Pinegrove Community Association - DSD- 2025-025 Staff Report Feedback

The staff report for 4611 King Street East OPA/ZBA utilizes a narrow selection of beneficial policies as its basis for recommending approval. There are numerous policies at the provincial, regional and municipal level that do not support this development to be approved in its current form. This report identifies each of these opposing policies in rebuttal to the DSD-2025-025 report. This document is intended to be reviewed alongside the DSD-2025-025 report.

Figure 5 - Walking distance to retail/commercial areas

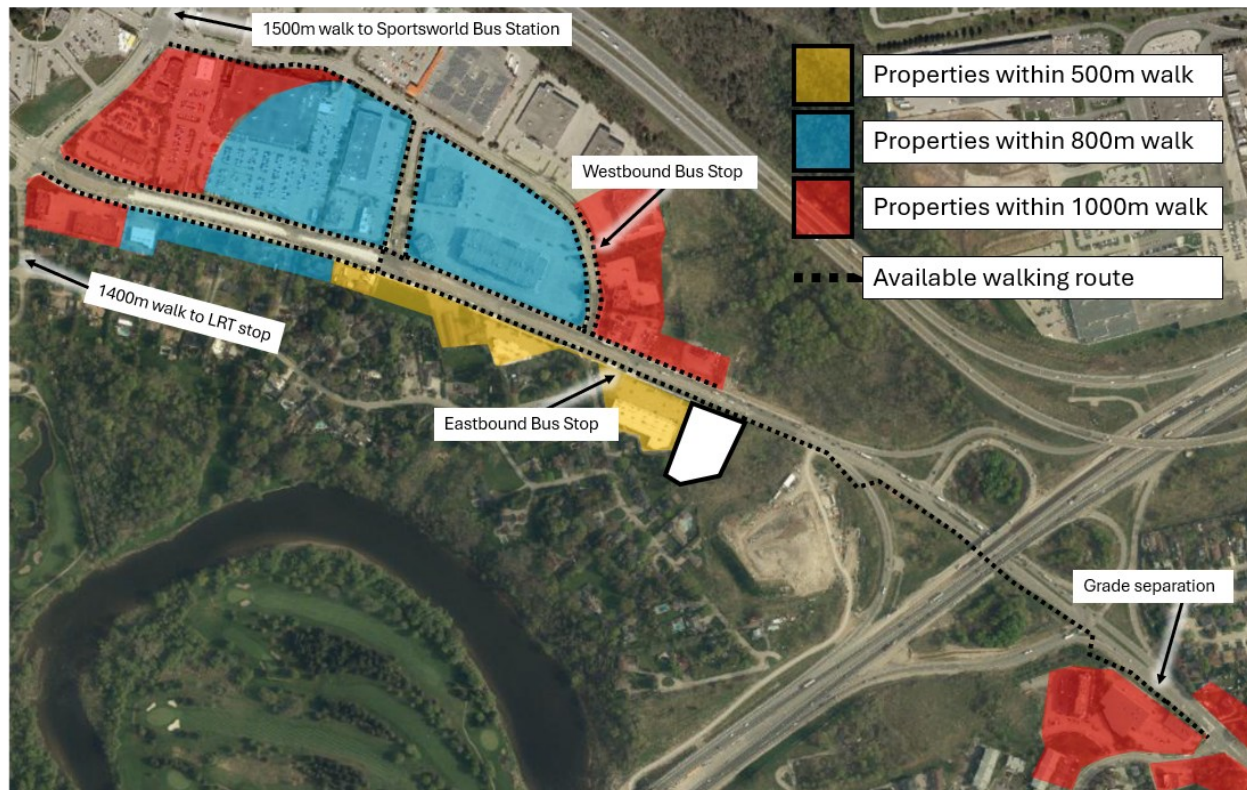
One example of the walkability challenges for this development is the path to the future LRT stop. Pedestrians will need to cross 20x driveways, 2x uncontrolled right-of-way street crossings, and 2x controlled right-of-way street crossings to catch the ION.

The diagram below demonstrates the walking limitations due to the current street configurations.

The limited walkability in this area is, in fact, intentional. The Region of Waterloo provides guidance on intersection spacing for this type of roadway:

Figure 6 -U-Turn access prior to LRT Stage 2

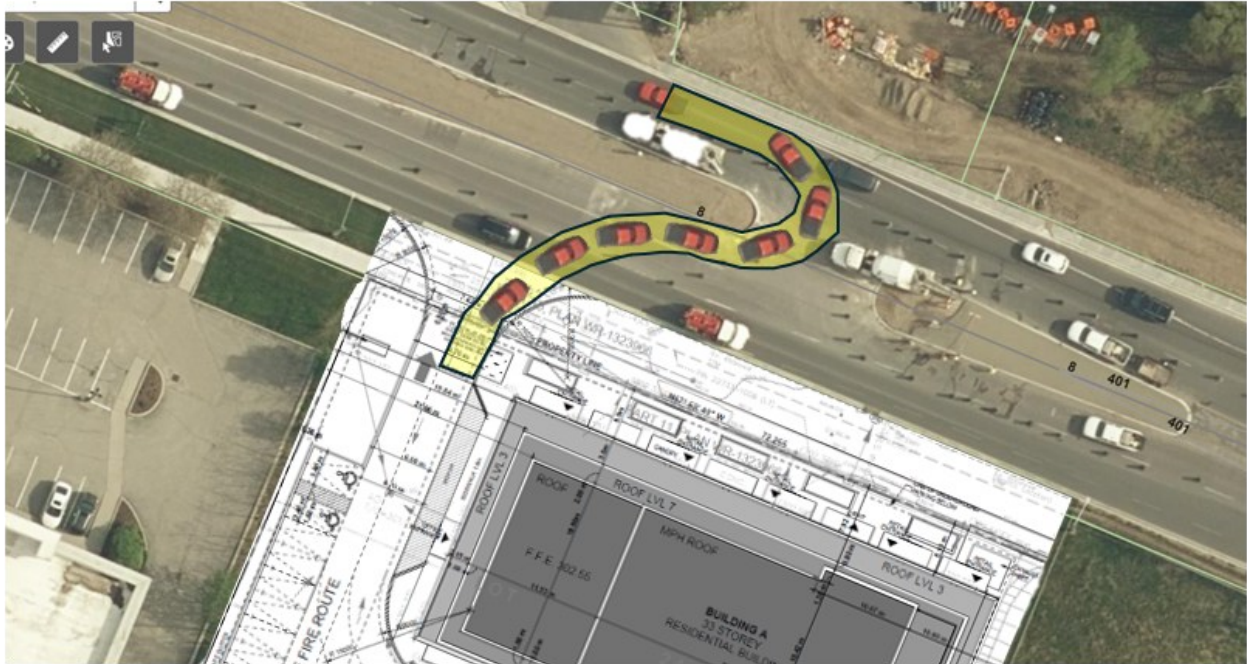
Both the applicant and ROW have suggested the use of a U-Turn in front of the site, see below figure.

Neither the applicant nor ROW have commented on the safety of this maneuver. In addition, the applicant has not studied this movement regarding queue times and queue capacity. The impact to queue times are expected to be significantly impacted due to this movement crossing two lanes of traffic instead of one.

Figure 7 – Walking distance from site to nearest westbound bus stop

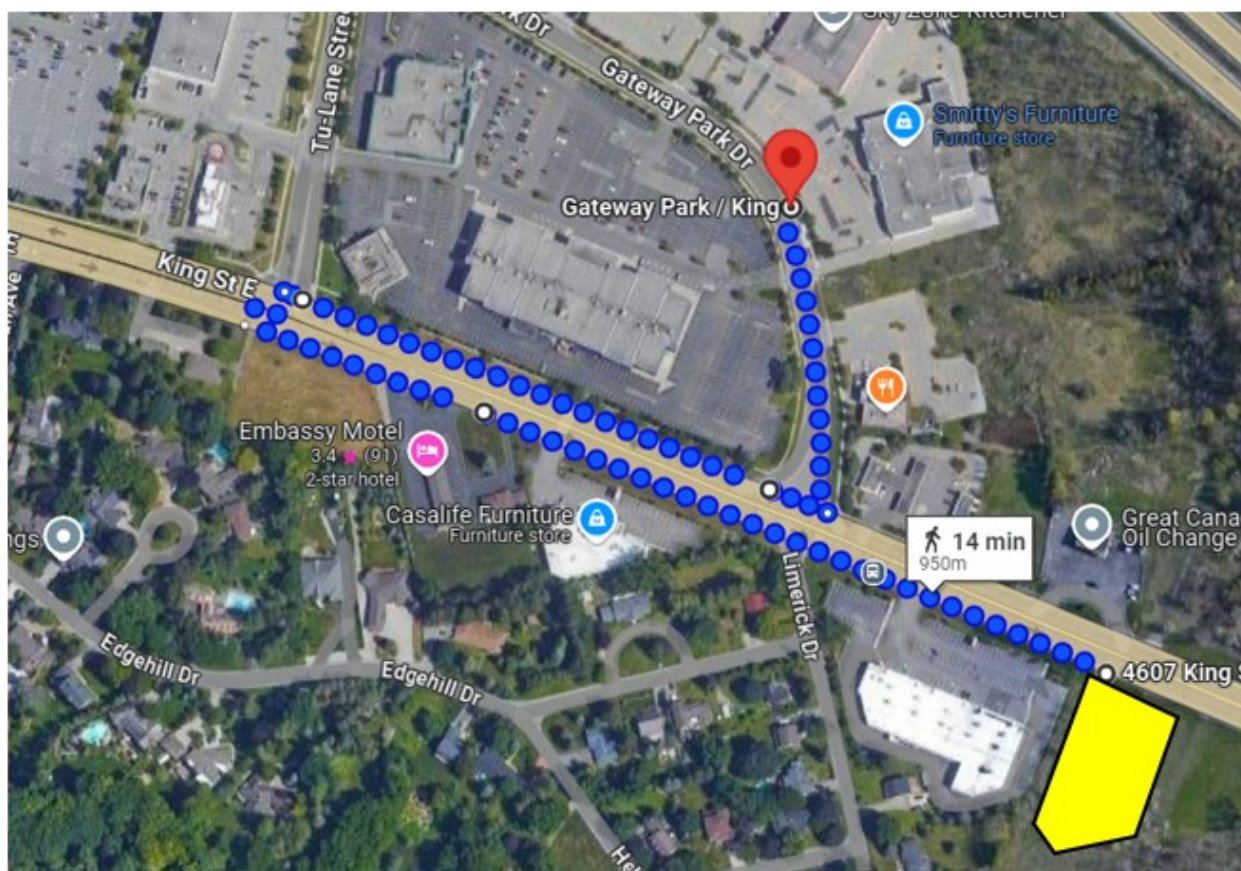
There is an eastbound bus stop with two routes within 450m, however as already indicated these routes do not connect with the greater transit network available at the Sportsworld station. The bus stop for the returning westbound routes is a 950m walk.

Figure 11 - Scale drawing comparison between 'Growing Together East' zoning plan and 4611 King St. proposals

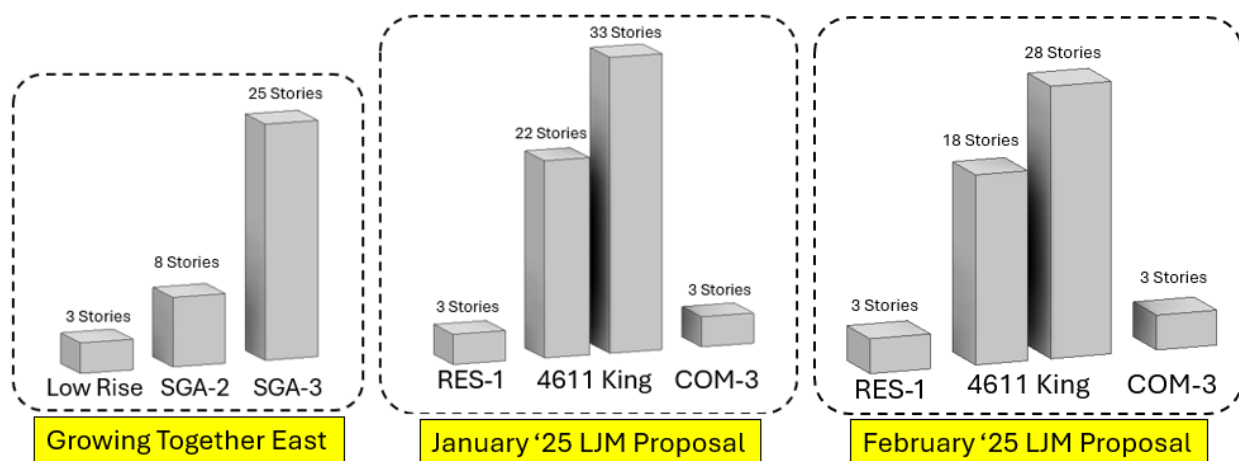
The ‘Mixed Use’ zoning by-law provides some additional context as to applicable adjacent zones. This land abuts a low-rise residential zone and an urban corridor and therefore could fall into either MIX-1 or MIX-2 by definition. The applicant is requesting MIX-3 which by standard regulation would be a maximum of 10 storeys, or 32 metres tall. The requested 18 storeys and 25 storeys are significantly above even MIX-3.

In conclusion, the transition is not suitable between the subject site and the adjacent neighbourhood in terms of scale, massing, building height, and intensity. This is supported by numerous Kitchener policies and guidelines, and such drastic transitions are not recommended by Kitchener for use in any existing or future PMTSA area.

Figure 14 - Cyclist access to broader cycling network

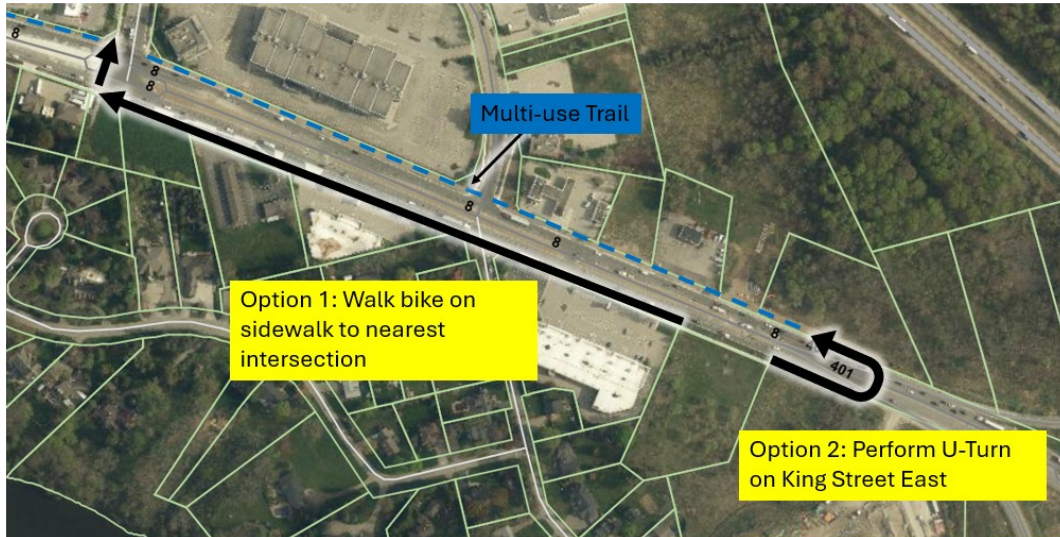
The applicant's TIS notes that a cycling network is available nearby, however provides no suggested connection to that network. There is currently no direct access to the cycling network from this site. Cyclists will have to choose between walking their bike ~500m or cycling on King Street East and making a U-Turn to access the broader cycling network. See below image for a representation of the two options available for cyclists to access the broader cycling network.
